# Final Decision

**File number(s):** CU 22-04 & DR 22-15

**Project name:** Hardcastle Apartments

**Date of decision:** March 9, 2023

Exhibit CU2 North spur walkway min width

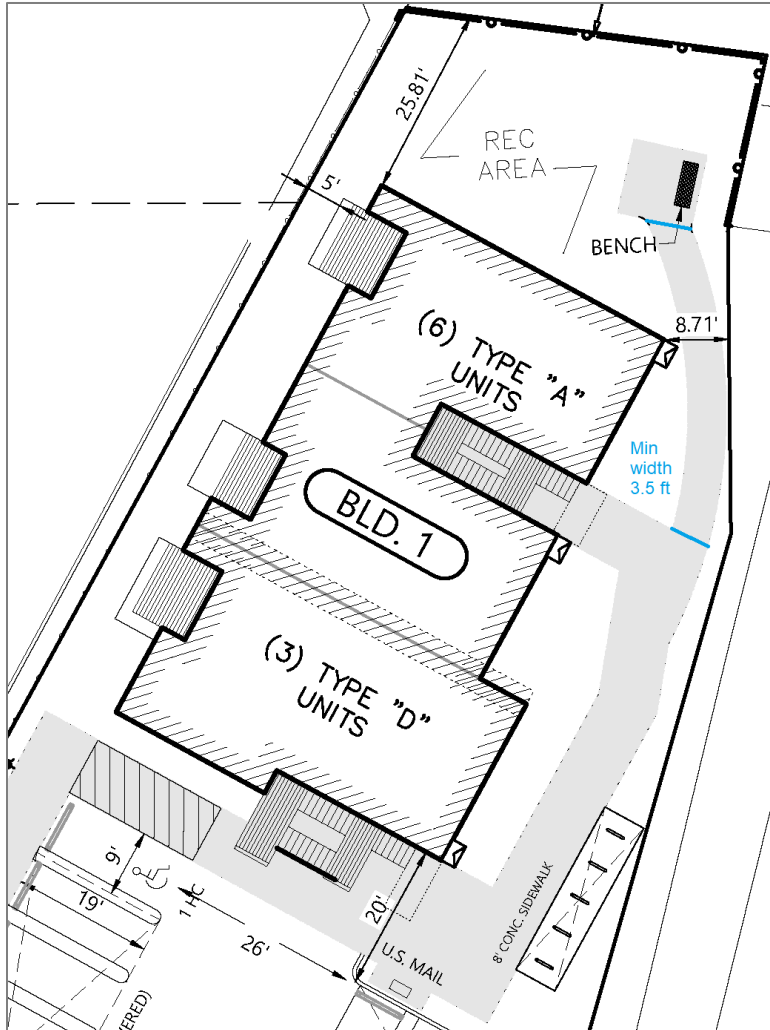
CU2. Walkways: The north spur walkway that passes the northernmost wide walkway segment serving the north open-air stairwell shall be min width 3.5 ft, allowing the applicant to narrow to provide more landscaping.

Exhibit CU5b EV max distance 50 ft

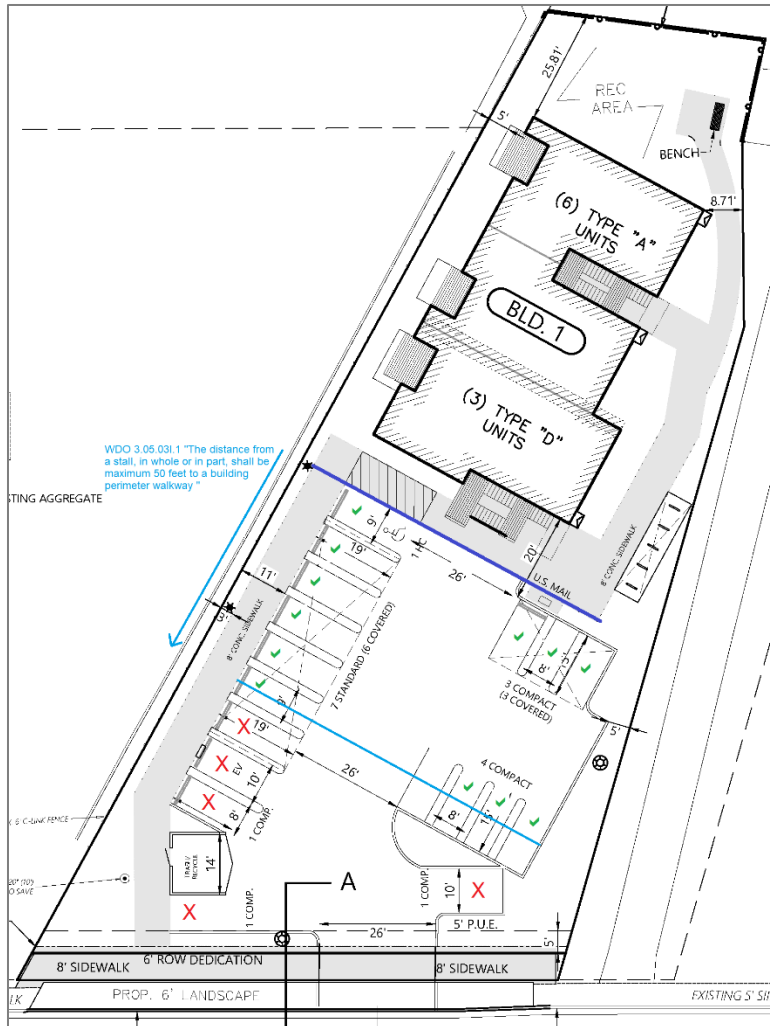
- a. Number: Electric vehicle parking shall be min 1 stall, as proposed, and to the standards of 3.05.03I.
- b. Revisions: The applicant shall per Condition G1 revise site plan Sheets SDR 3, SDR 3.1, or building permit plan set equivalent sheets to meet 3.05.03I.1 (max distance 50 ft) per Exhibit CU5b below, 2 (technical specs), 3 (pavement image or logo), & 4 (sign face image or logo).

Exhibit CU11 decorative paved areas outlined in dark red and shaded beige

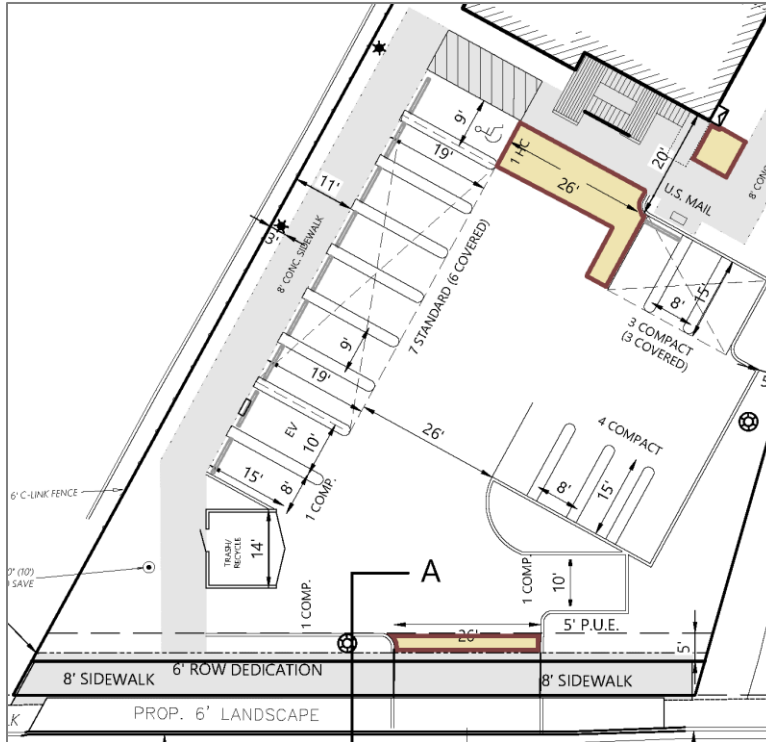
CU11. Decorative paved area: Vehicular circulation area shall be paved with any of decorative bricks or pavers or paved with concrete that is scored, stamped, or otherwise treated to have a pattern as described below and Exhibit CU11 conceptually illustrates:

- a. North: Min extent 9 ft south from the parking area north curb and min width equal to the distance between the accessible/ADA parking stall at the west/NW and the curb and parking stall at the east/SE. The area shall “dogleg” or extend south along the east parking stall whole west side at min width 4 ft.
- b. South: Within the driveway throat, equal to its width and min depth same as the landscaped peninsula to the west.

Exhibit CU14b(2)(a)

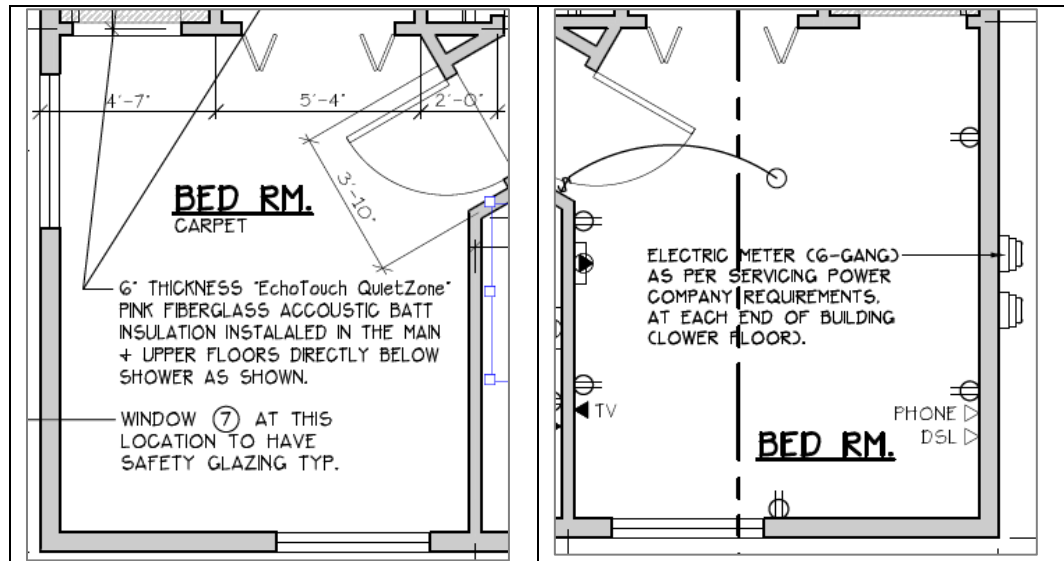
- (2) Windows:
    - (a) Per room: Per room: Within apts., every habitable room abutting a building exterior wall shall have min 1 window. Each ground floor corner room proposed through land use review to one on each elevation shall continue to have 2; however, where the developer to propose additional location(s) of exterior wall-mounted utilities and meters, then for each room, the second window may shrink to min 6 sq ft and be horizontally proportioned.

Exhibit CU14b(2)(b) Narrow wall windows

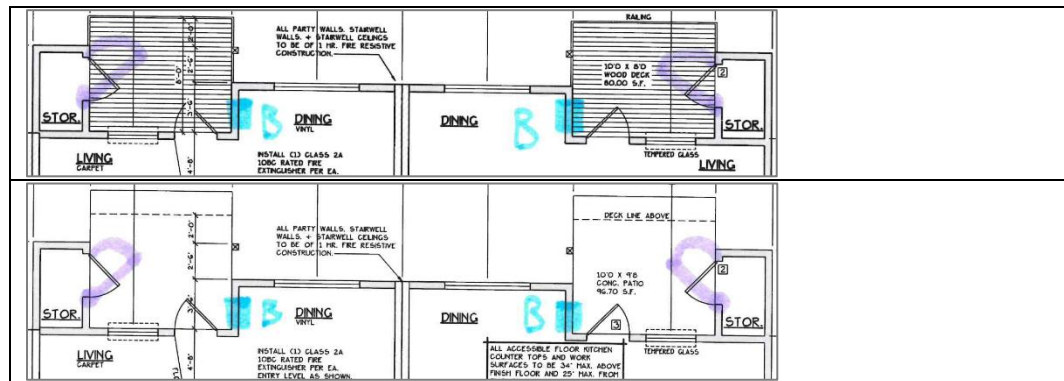
- (b) Narrow wall: For units with floor plans resembling Exhibit CU14b(2)(b) below with 3 ft or more off-set, each rear in the wall dividing dining/living area and patio or balcony shall have a window min width 1.5 ft and min area 6 sq ft approximately where the blue letter “B” indicates.

CU 22-04 Hardcastle Apts.:  
Attachment 202: Tree Protection

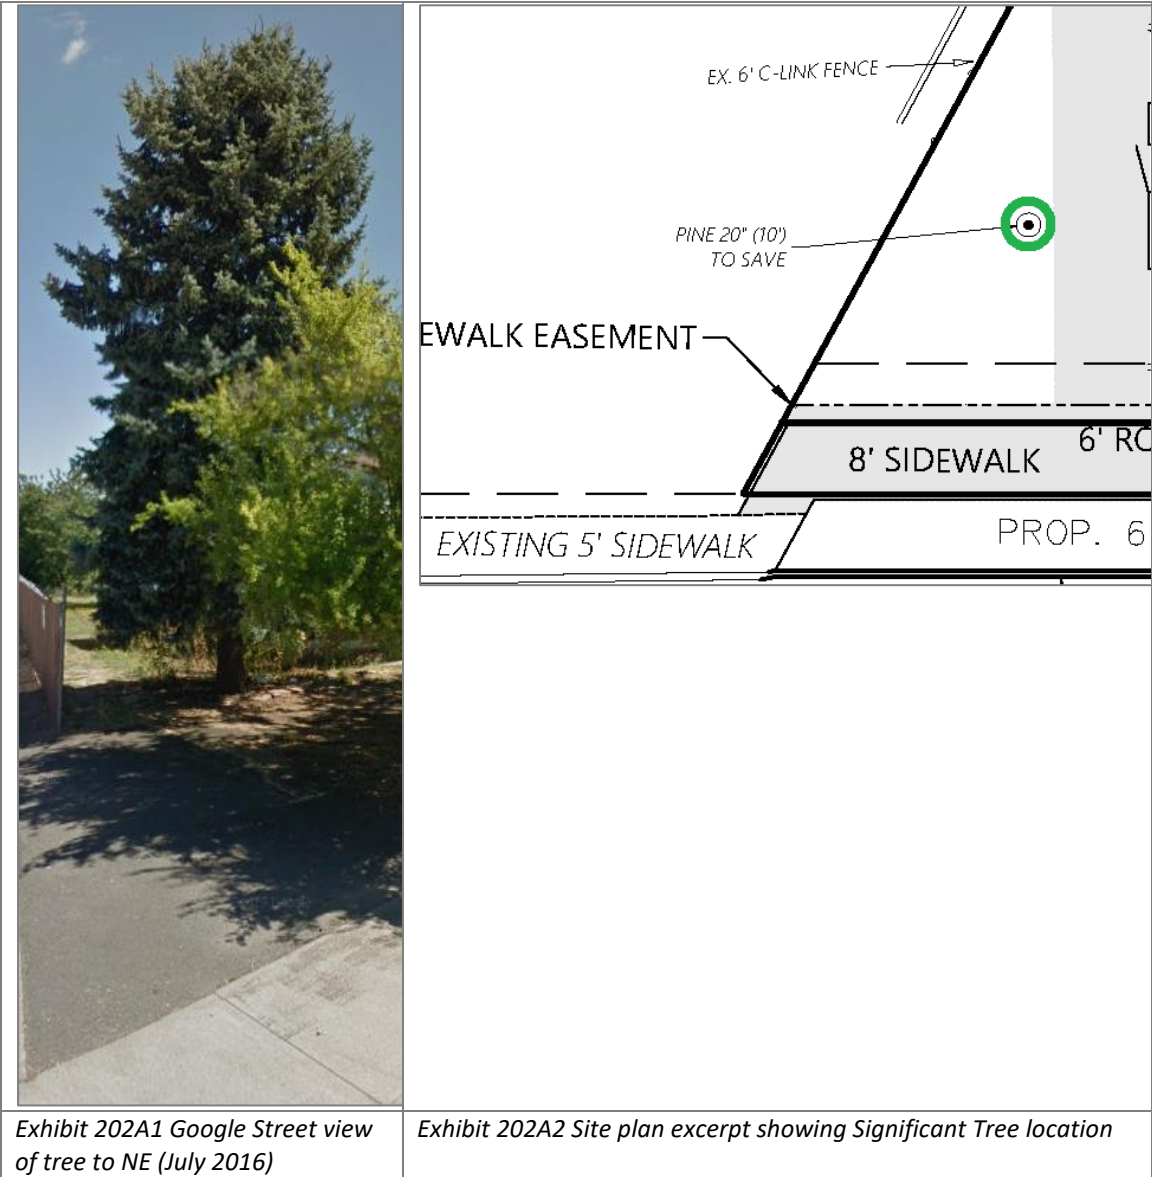
1. The developer shall preserve the Significant Tree, a 24-inch pine at the site SW corner.
